# UNITED STATES PATENT AND TRADEMARK OFFICE

APPLICATION NO.	FILING DATE	FIRST NAMED INVENTOR	ATTORNEY DOCKET NO.	CONFIRMATION NO.
10/005,845	12/03/2001	Shuki Vitek	266/217	3098

**Office Action Summary**

## **DETAILED ACTION**

Fig. 2.

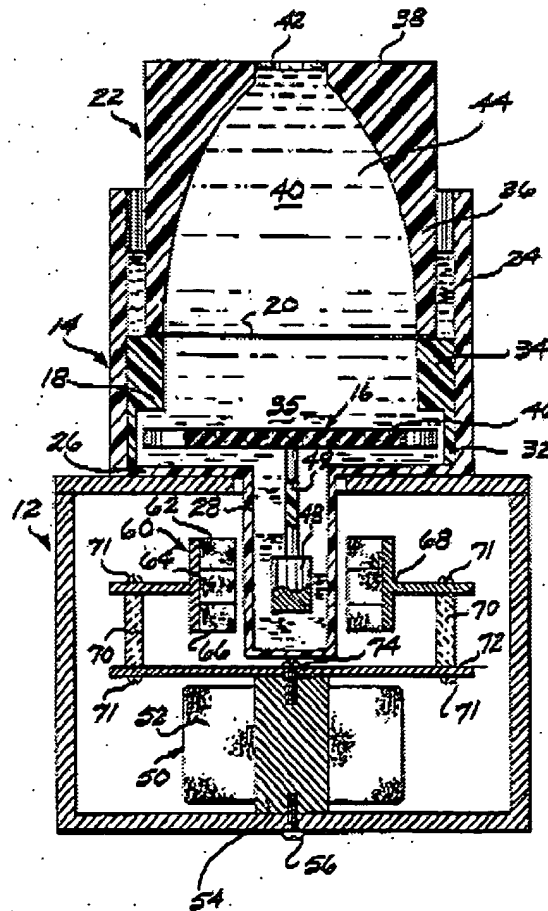
In regard to claims 1 and 9, Nelson teaches in Fig. 2 (reproduced below), an apparatus/system for measuring power of acoustic energy of an ultrasound transducer (col. 1, lines 15-18) comprising: a container/housing (14) comprising a fluid (44) inherently having a first density therein; a buoyant body (16) floating in the fluid, the buoyant body inherently having a second density less than the first density since it floats at a first level in the fluid inside

the container when the buoyant body is not impacted by acoustic energy (col. 5, lines 4-15)

wherein the buoyant body comprising a wave receiving surface (46). Nelson further teaches that when the wave receiving surface (46) is impacted by acoustic energy, the buoyant body floats at a second level wherein the displacement of the buoyant body between the first and second levels being directly related to the power of the acoustic energy transmitted by the transducer (col. 1, line 35).

*Fig. 8.*

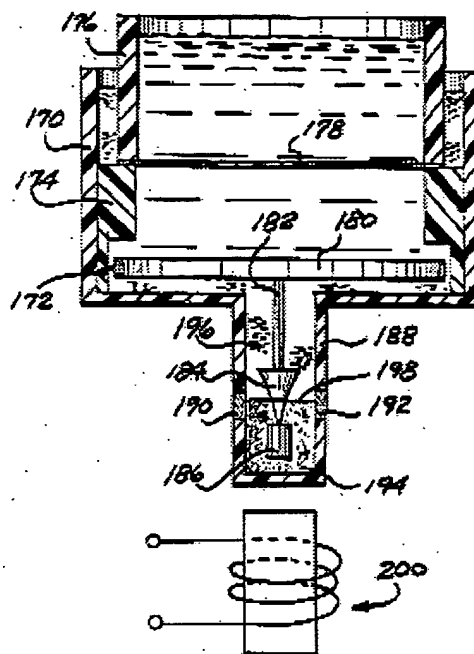
In regard to claim 6, Nelson teaches in Fig. 8 (reproduced in the next page), a first fluid (194) having a first density, a second fluid (196) having a third density less than the density of the buoyant body (172), wherein the second fluid (196) is disposed above the first fluid (194) such that the buoyant body (184 of the buoyant body 172) floats at a boundary (198) between the first and second fluids.
